HISTORIC AND DESIGN REVIEW COMMISSION

March 3, 2021

HDRC CASE NO:	2020-196
ADDRESS:	ROW near 955 S ALAMO ST
LEGAL DESCRIPTION:	NCB 741 BLK 4 LOT SE 111 FT OF 21
ZONING:	С-2, Н
CITY COUNCIL DIST.:	1
DISTRICT:	King William Historic District
LANDMARK:	A & E Food Market
APPLICANT:	Kevin Bowyer/Modus LLC
OWNER:	City of San Antonio
TYPE OF WORK:	Installation of a new network wood pole
APPLICATION RECEIVED:	April 14, 2020
60-DAY REVIEW:	Not applicable due to City Council Emergency Orders
CASE MANAGER:	Huy Pham

The applicant is requesting a Certificate of Appropriateness for approval to install a new wood pole to feature network node equipment, including trenching for electrical power.

ALTERNATIVES ANALYSIS

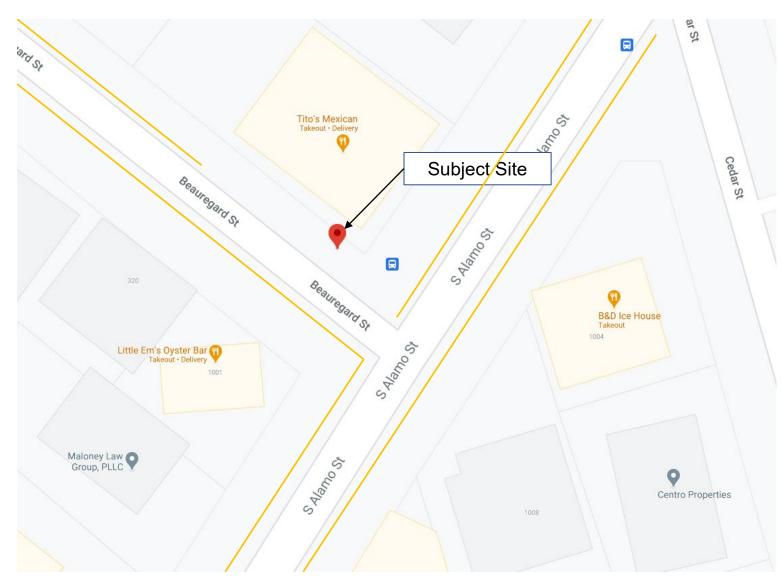
- i. COLLOCATION Documented efforts to explore a nearby collocation have not been submitted.
- ii. SEPARATION The proposed pole is not separated from existing poles by more than 250 feet.
- iii. DIAMETER The proposed pole is not less than 8 inches at its widest portion.
- iv. DESIGN Matching wood material to existing poles does not constitute a stealth aesthetic.

Existing CPS wood utility poles – not viable due to the pole having transformers, air switches or other CPS equipment on them that CPS does not allow (see next page)

No existing viable vertical assets. All nearby CPS poles are not viable colocation candidates since they are either transformer poles or have risers on them which CPS doesn't allow
